## Summary of Items Discussed in 1/2024 APSEC Discussion Forum (ADF) on 23 February 2024

Diagram 1

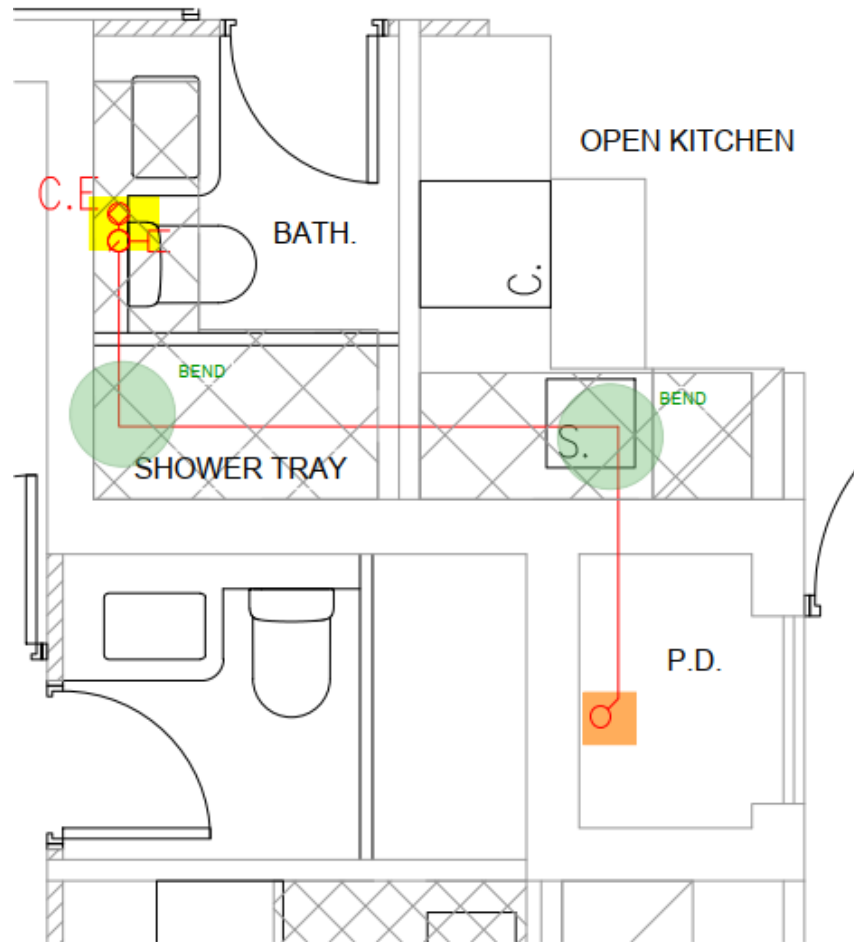
<p>Would BD consider accepting temporary metal scaffolding as the M&amp;R access for the external wall of top roof structure with tile finishes only?</p>	
<p>5.</p>	<p><b><u>Cleaning Eye Provision for Drainage</u></b></p> <p>According to regulation 28(2)(b) of the Building (Standards of Sanitary Fitments, Plumbing, Drainage Works and Latrines) Regulations (B(SSFPDWL)R), a cleaning eye or other suitable means of access shall be provided at or near the bend of soil pipes and waste pipes. Diagram 1 below demonstrates a common approach for the cleaning eye provision, i.e. every bend served by at least 1 no. of cleaning eye / access through a straight drainage pipe within a reasonable distance. In some drainage plan submissions, BD required that cleaning eye should be provided right at the bend or within a very close distance from the bend as marked in green in Diagram 2. The requested cleaning eye provision might be in conflict with the shower tray / bath tub, and induced difficulty in the layout planning.</p> <p>We consider that Diagram 1 is also acceptable to fulfill the requirement in regulation 28(2)(b) of B(SSFPDWL)R. Would BD please clarify whether our understanding is correct or not?</p>	<p>BD advised that access points in sunken slab should be provided to facilitate inspection of every part of the pipe works and clearance of any blockage thereof in accordance with paragraph 5 of PNAP APP-93.</p> <p>BD also advised that the design of the drainage system illustrated in Diagrams 1 and 2 required further clarification to demonstrate the effectiveness and workability of cleaning.</p> <p>BD supplemented that practitioners were being consulted on the design and testing of drains in sunken slab for the preparation of the Code of Practice for Drainage in Buildings. Members were encouraged to provide their views on the matters.</p>

-  CLEANING EYE
-  MODIFICATION ITEM - TO USE COUPLING JOINT WITH RUBBER GASKET COLLAR FOR EASY INSTALLATION AND ACCESS IN LIEU OF CLEANING EYE FOR DRAINAGE SYSTEM.

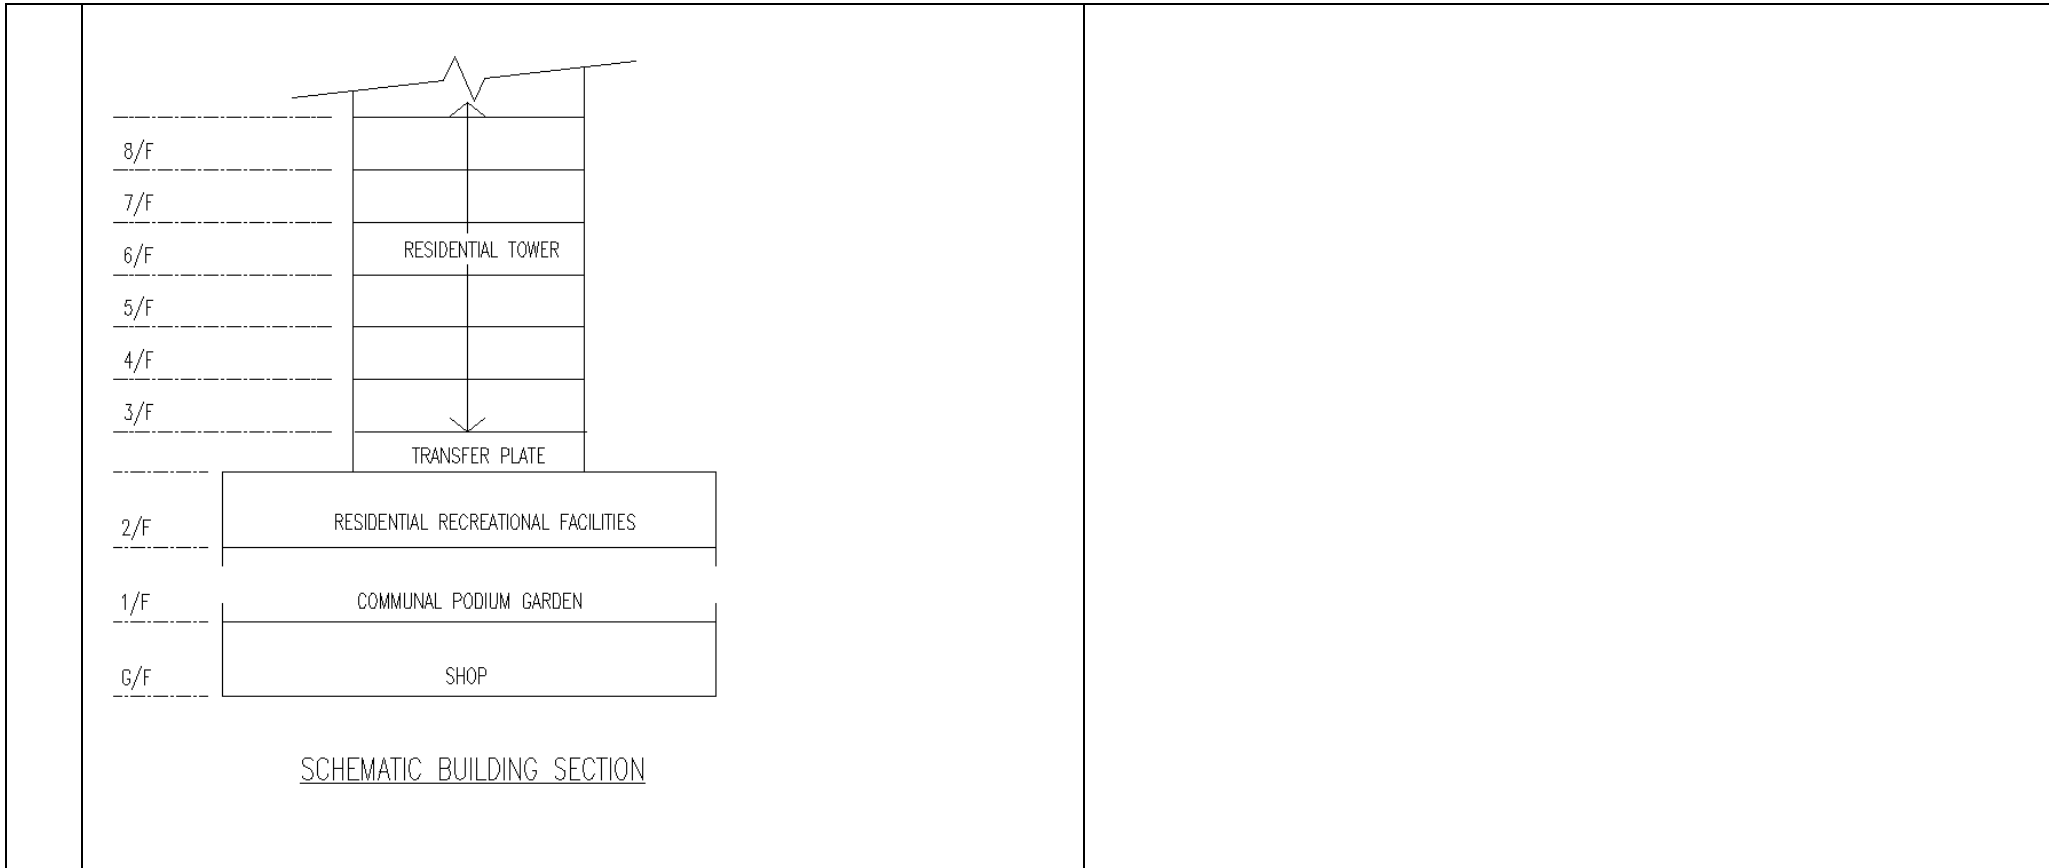
7.	<p><b><u>“Atrium” in Clause C10.3(a) of FS Code</u></b></p> <p>It was discussed in item 2 of ADF 2/2023 held on 5 May 2023 that it was not the intention of BD to restrict uses (such as retail shops, cafeteria, pop-up stores, kiosks, etc) within the atrium compartment. Following the above, we understand that the atrium compartment is not merely restricted to the void space and the circulation aisle along the perimeter of the atrium void, but can also include the mercantile facilities beyond the aisle at each floor adjoining the atrium void (without any fire rated separation from the void) as indicatively illustrated in the following sketch section. Please confirm that our understanding is correct.</p>	<p>BD advised that according to Clause C10.3(a) of the FS Code, an atrium should be separated from all other spaces by fire barriers having an FRR of not less than that of those spaces. The commentary to Clause C10.3 supplemented that there was a risk of smoke spread at the atrium that could affect adversely the life safety of the occupants, especially on upper floors of the atrium.</p> <p>Hence, the volume of an atrium should mainly include the atrium itself and fire barriers should be provided to separate the atrium from other</p>

<p>LEGEND:</p> <p><span style="border: 1px solid red; display: inline-block; width: 15px; height: 10px; vertical-align: middle;"></span> ATRIUM COMPARTMENT <math>\leq 28,000\text{m}^3</math></p> <p>----- NOTIONAL SHOP-FRONT OR NON-FRR SEPARATION</p>	<p>spaces including shops.</p> <p>Noting that the atrium might be of irregular shape and the alignment of fire shutters along the edge of atrium might be impractical, BD would consider accepting minor arcade and circulation areas adjoining the atrium with relatively low fire risk to be included as part of the atrium compartment. However, mercantile facilities outside the atrium would not be accepted to be included within the same compartment of the atrium void.</p>
<p><b>Items raised by HKIE</b></p>	
<p>8. <b><u>Cast-in Embed</u></b></p> <p>To streamline the approval process, it is suggested to treat the cast-in embeds as typical structural elements with all typical details given in superstructure plans. The design load, alignment and exact location shall be shown in the structural submission for the secondary building elements. Modification of regulation 33(1) of the Building (Administration) Regulations for the installation of cast-in embeds can be applied for once the first consent to the commencement of the superstructure works has been granted.</p>	<p>BD welcomed the proposed streamlining measure. BD advised that structural details, design standards, material specifications, design load and general locations of the cast-in embeds should be clearly indicated in the first submission of superstructure plans, while their exact locations, layout and setting-out could be provided in the subsequent superstructure amendment plans or the structural plans for the corresponding secondary building elements.</p>

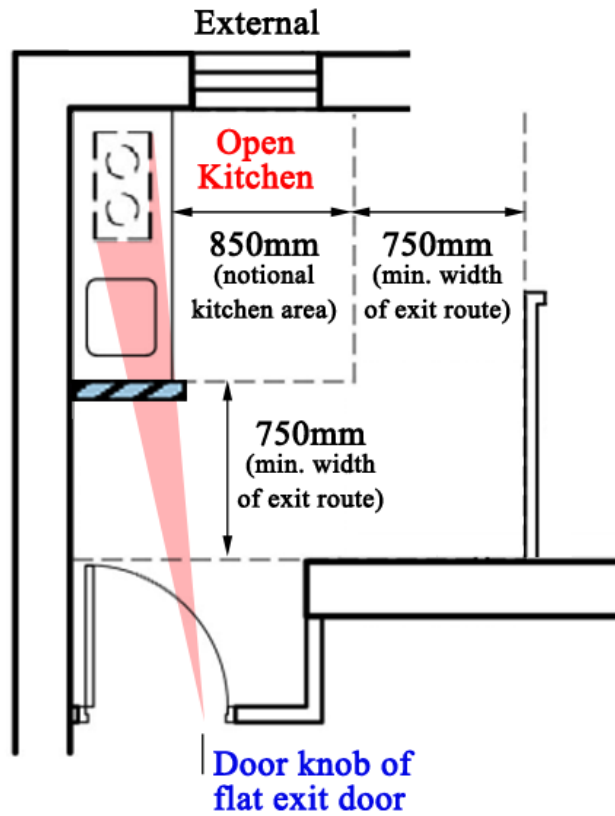
16.	<p><b><u>Drainage of Refuse Storage and Material Recovery Chambers</u></b></p> <p>According to regulation 11(1) of the Building (Refuse Storage and Material Recovery Chambers and Refuse Chutes) Regulations (B(RSMRC&amp;RC)R), <i>“every refuse storage and material recovery chamber (RSMRC) shall be provided, in the floor thereof, with an outlet drain.”</i> As per our understanding, there is no requirement of surface channel to be provided near the entrance door in RSMRC. Please advise whether our understanding is correct.</p>
	<p>BD advised that soldier pile might be used as permanent structure, provided that apart from the Code of Practice for Foundations 2017, assessments with regard to different codes of practices and standards were conducted for consideration by BD and GEO. BD would further discuss with GEO regarding the design and acceptance criteria of the permanent soldier and pipe pile wall.</p> <p>BD advised that there was no requirement on the provision of surface channel near the entrance door of the RSMRC.</p> <p>BD also advised that the outlet drain should be provided on the floor of RSMRC to facilitate cleansing of the floor. In accordance with regulation 11(2) and 11(3) of the B(RSMRC&amp;RC)R, the outlet drain should also be connected to a back inlet trapped gully for inspection and clearance of blockage in the pipe.</p>

Also, can the outlet drain be in the form of vertical grating instead?	
17.	<p><b><u>Location of Manholes in Car Park</u></b></p> <p>As there is no restriction on the location of manholes in the car park area, can the manhole or the associated drainage pipes located within the private car parking area be acceptable by the Building Authority (BA), considering that the car can be easily relocated to other places for maintenance of the manhole/drainage pipes, if required? Please advise whether our understanding is correct.</p>	<p>BD advised that all manholes or associated drainage system located at the car parking floors should be conveniently and safely accessible for frequent inspection and routine maintenance to meet the spirits in PNAP APP-93. Manholes or associated drainage system not accessible through common area in car park might also be acceptable if central management and control by a party with the right of entry was available at appropriate time to facilitate frequent inspection and routine maintenance.</p>
